Flight Procedures Cover Page	Task Action: FLIGHT CHECK	Task Type: IAP	Estimated Chart Date: 09/10/2020	APWS Task ID: ADCEEA534D04BE8A33B6A5D80CE3156	APWS Project ID: 73FBB13F791944C5B8B562A14EF5A140
Procedure: RNAV (RNP) Z RWY 13R AMDT 2		Enroute: NO	Specialist: Garrity, Michael		Agreement Number:
Airport ID: KDFW	Airport Name: DALLAS-FORT WORTH INTL		Airport City: DALLAS-FORT WORTH		State: TX
Facility ID:	Facility Type:	Flight Inspection Remark Type: Hold FC Slot			
<p>Procedure Comments: PENDING DATA USED FOR KDFW AIRPORT AND RUNWAYS</p> <p>8260-1 (1): FAAO 8260.58A, PARA 1-2-5C(3)(B)(2) - THE BANK ANGLE OF THE MISSED APPROACH RF LEG FROM HADZZ TO GR7CH IS 25 DEGREES AND EXCEEDS THE MAXIMUM OF 20 DEGREES ALLOWED BY CRITERIA FOR XTT VALUES OF LESS THAN 1.0.</p> <p>LOA (1): FAAO 8260.58A, PARA 1-2-5C(2), TABLE 1-2-2, NOTE 2 - FLIGHT STANDARDS APPROVAL IS REQUIRED FOR MISSED APPROACH RESTRICTIONS OF OTHER THAN OBSTACLE AVOIDANCE</p> <p>CONTACT: ALLAN WILL, TEAM 2 SUBTEAM-C MANAGER, 405.954.6103, OR MARLON ROBINSON, TEAM 2 MANAGER, 405.954.3636</p> <p>06/11/20: THIS IS AN UPDATED COPY OF THE FORM DEVELOPED ON 04/02/20.</p> <p>1. 8260-3: CHANGED MISSED APPROACH AIRSPEED RESTRICTION TE

RNAV (RNP) Z RWY 13R

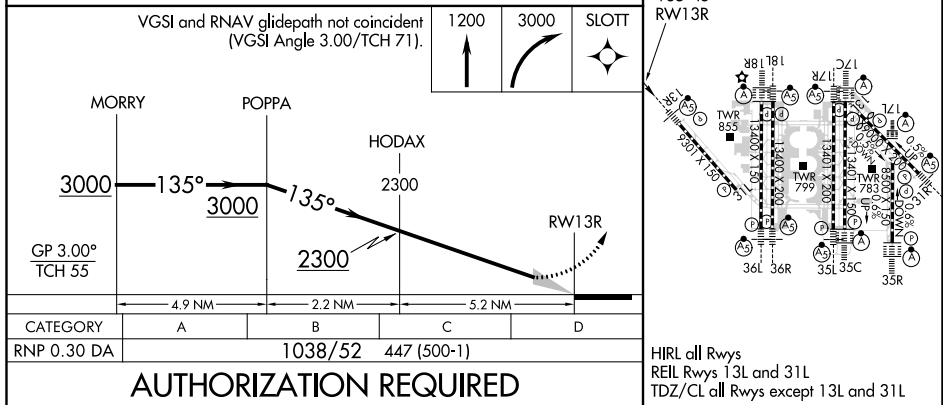
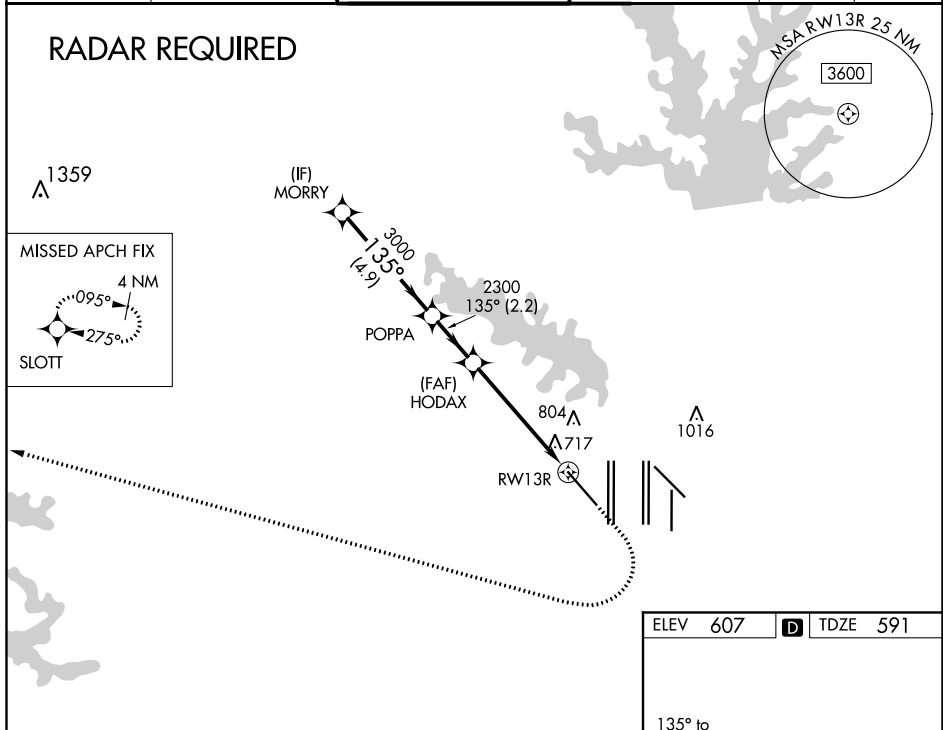
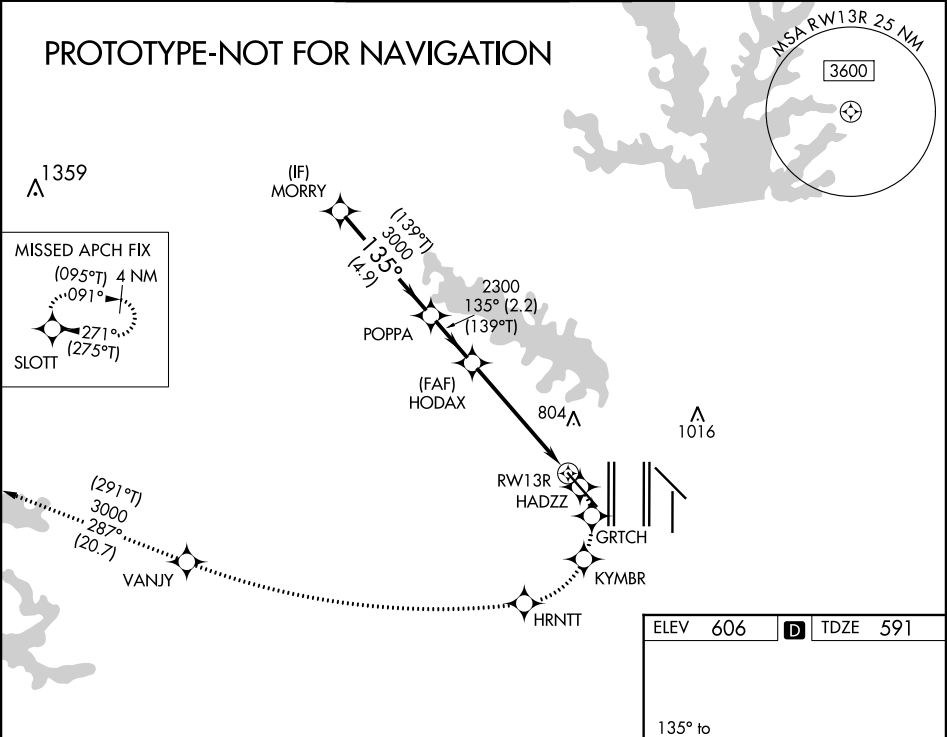
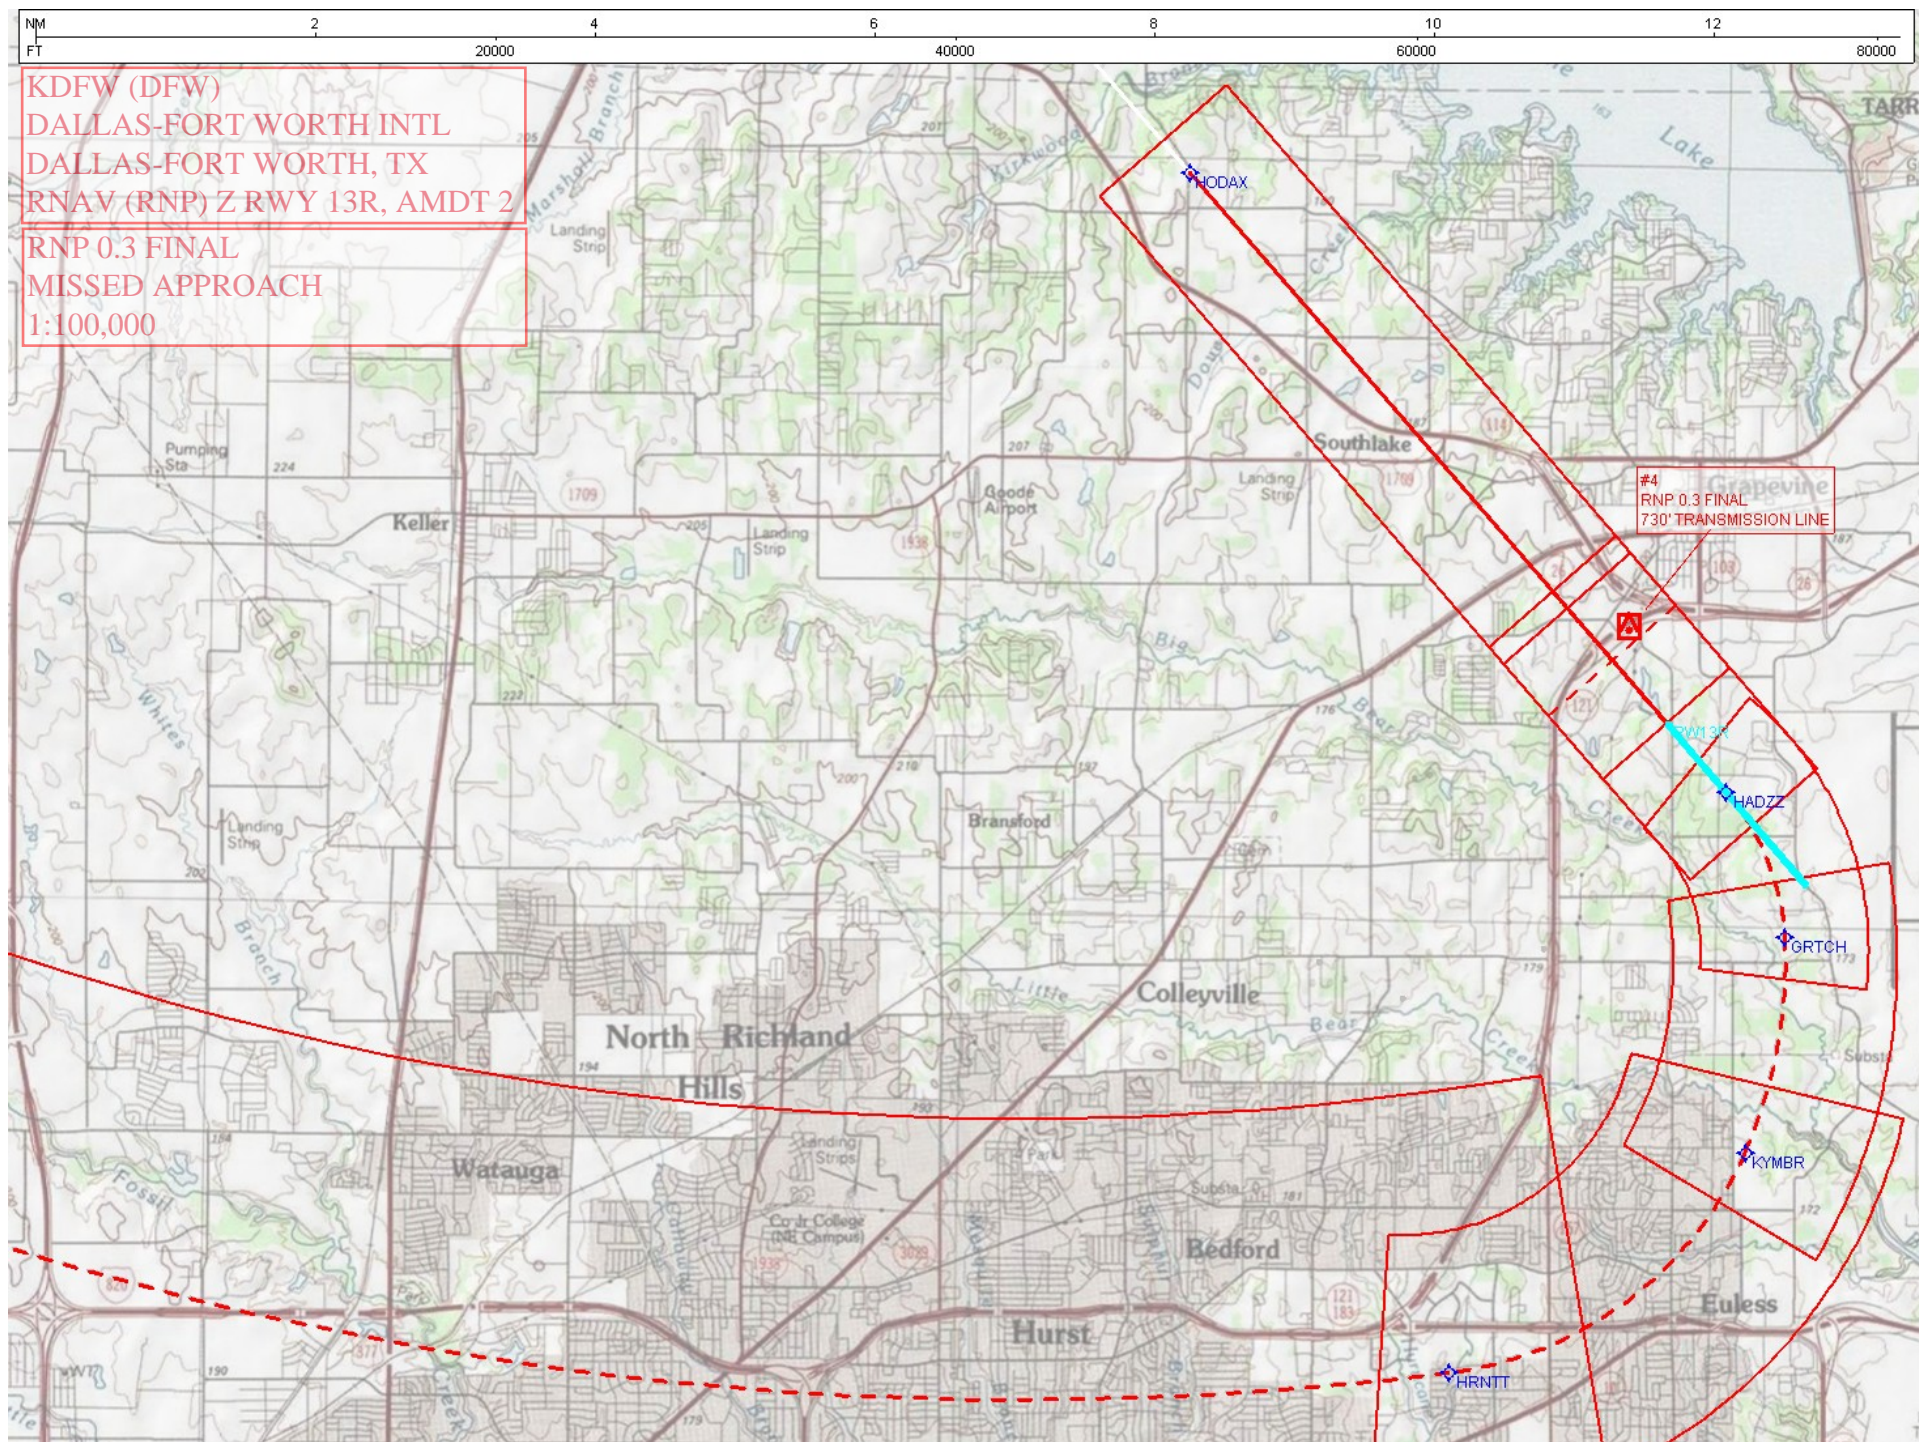
FAAO Order 8260.58A, paragraph 1-2-5c(3)(b)(2). The bank angle of the missed approach RF leg from HADZZ to GRTCH is 25 degrees and exceeds the maximum of 20 degrees allowed by criteria for XTT values of less than 1.0.

As currently published, the protected airspace for the KDFW RNAV (RNP) Z RWY 13R missed approach route overlaps the departure trapezoid for KDFW RWY 18L. To remove this overlap and to assist in mitigation of CRO operations, the missed approach path was redesigned to include a 185 KIAS speed restriction and an RF right turn that exceeds the maximum bank angle of 20 degrees.

KDFW RNAV (RNP) Z RWY 13R Missed Approach Segment has been redesigned to assist in mitigation of CRO operations. The speed assignment of 185 knots at the MAP is necessary to permit a turn radius and bank angle necessary to avoid KDFW RNAV (RNP) Z RWY 13R missed approach route width protected airspace from over lapping with the departure trapezoid of KDFW RWY 18L.

RNP AR APCH. RF required.		<div>MALSR</div> <div></div>	MISSED APPROACH: (Do not exceed 185 KIAS until HRNTT) Climb to 3000 on the RNAV missed approach route to SLOTT and hold.
<div></div> <div>For uncompensated Baro-VNAV systems, procedure NA below -6°C or above 54°C. Missed approach requires RNP less than 1.0.</div>
